# UNITED STATES PATENT AND TRADEMARK OFFICE

APPLICATION NO.	FILING DATE	FIRST NAMED INVENTOR	ATTORNEY DOCKET NO.	CONFIRMATION NO.
10/506,295	04/28/2005	Takuma Iida	MATS:049	8664
7590 03/24/2006				
Rossi & Associates PO Box 826 Ashburn, VA 20146-0826		EXAMINER TIBBITS, PIA FLORENCE		
		ART UNIT PAPER NUMBER		
		2838		
DATE MAILED: 03/24/2006

BATTERY PACKAGE AND METHOD OF CHARGING AND DISCHARGING THE SAME  
Takuma IIDA, et al; SN. 10/506,295  
Replacement Sheet

FIG. 1

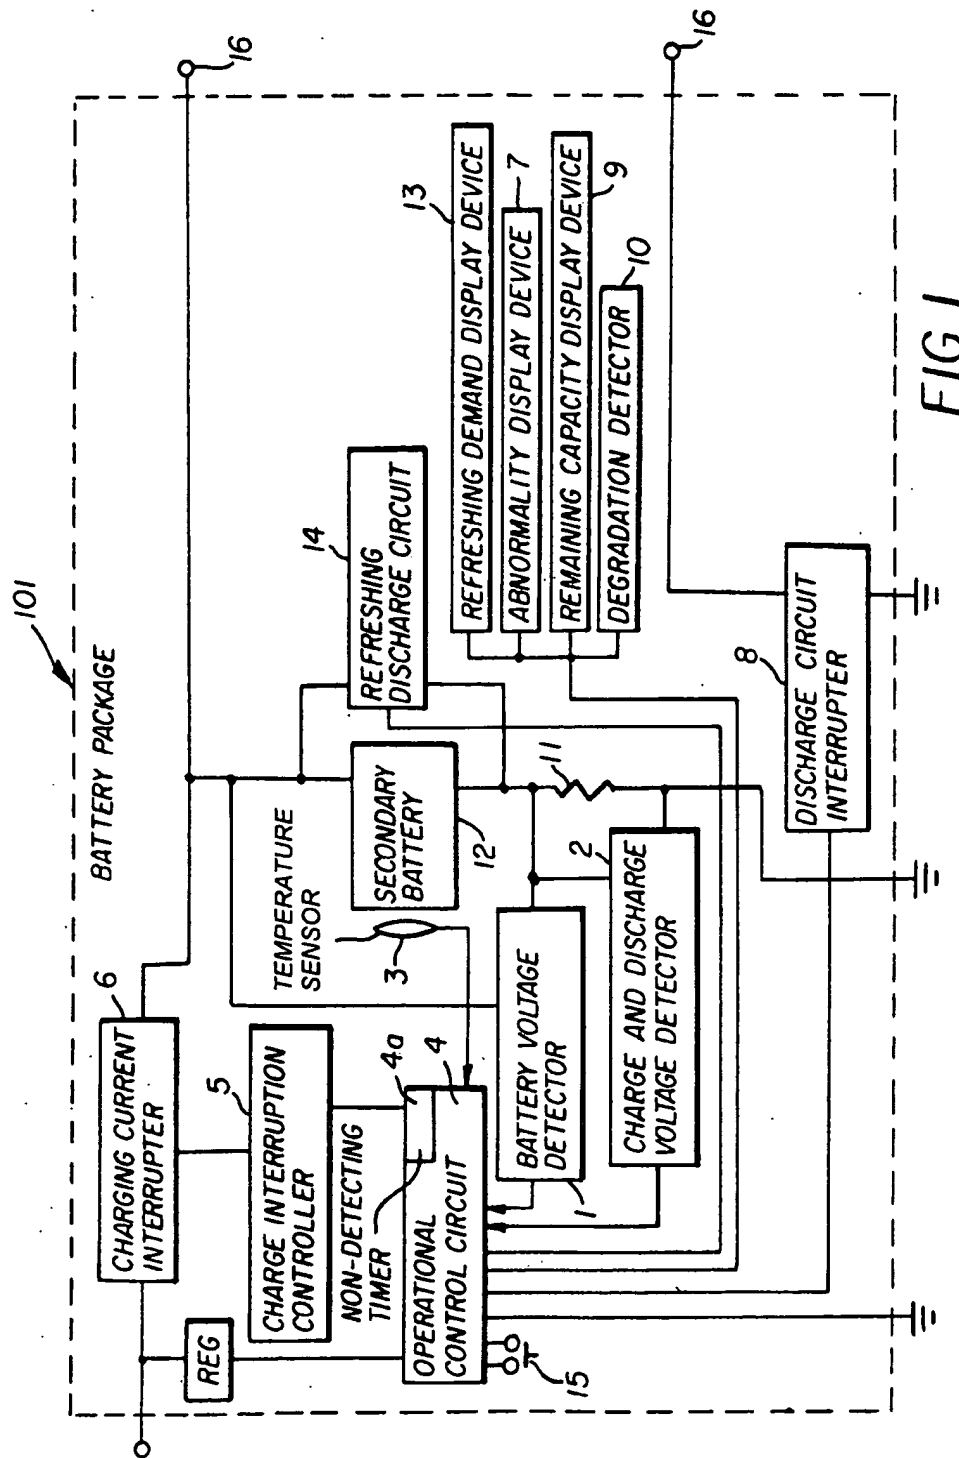
1. The specification has not been checked to the extent necessary to determine the presence of all possible minor errors. Applicant's cooperation is requested in correcting any errors of which applicant may become aware in the specification. For example, element 4a shown in the replacement drawing is not described in the specification.
2. The specification is objected to as failing to provide proper antecedent basis for the claimed subject matter: "the secondary battery does not exceed a preset voltage". See 37 CFR 1.75(d)(1) and MPEP § 608.01(o). Correction is required.
